Quality Bulletin

**Recall R19931: Front Seat Rail Flange Nuts
Model Year 2018 - 2019 XC60 & S90**

| Title | Front Seat Rail Flange Nuts | Page | 1 (4) |

Check

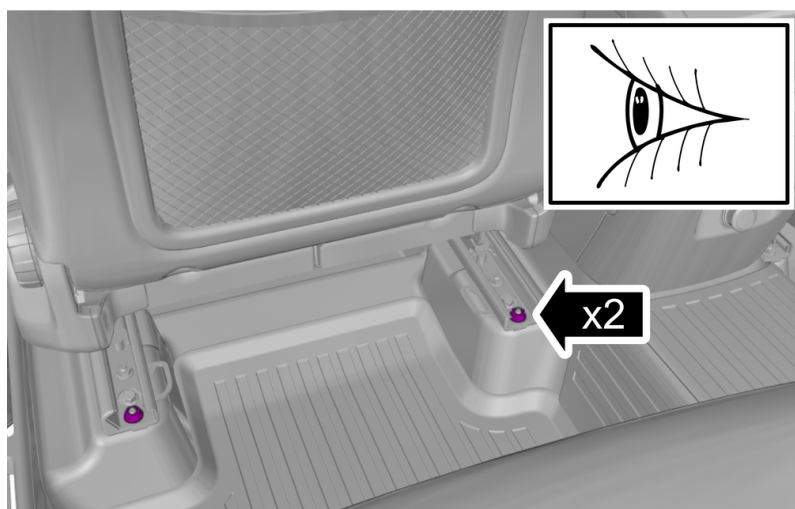
Make sure that the rear flange nuts are installed on both front seats.

Installation

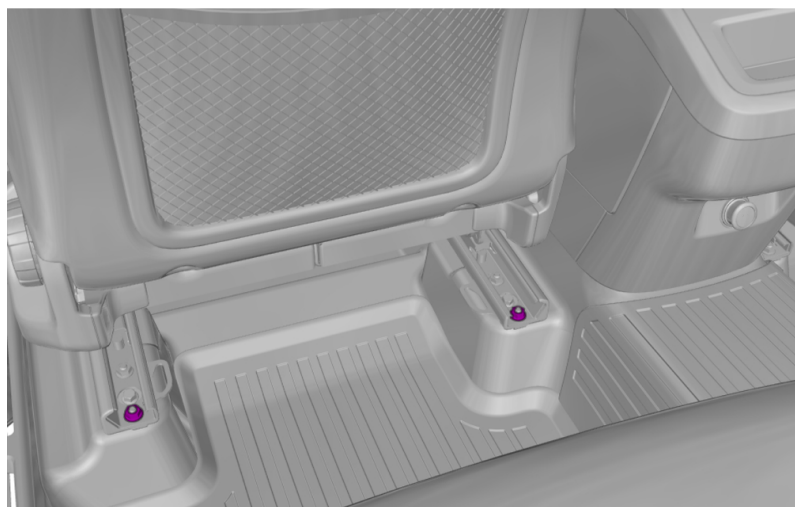
Inspect and install nut/nuts if missing.

If the nuts are in place no further action is needed.

Torque if installation of flange nuts is needed:

Seat track, to seat , 22 Nm
